This report comments on the seismic performance of a Reinforced Concrete Frame building with masonry infill walls situated near the IIT Kanpur main campus entrance gate.

Building description: It's a two storey RC building with masonry infill used for commercial purposes. It's situated near a railway line.

Figure 4 Exposed reinforcement

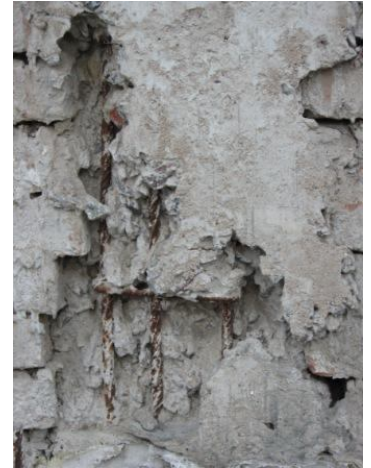
Poor construction practices were followed. Exposed reinforcements, pipe installation through the load walls and beams could be seen in the structure.
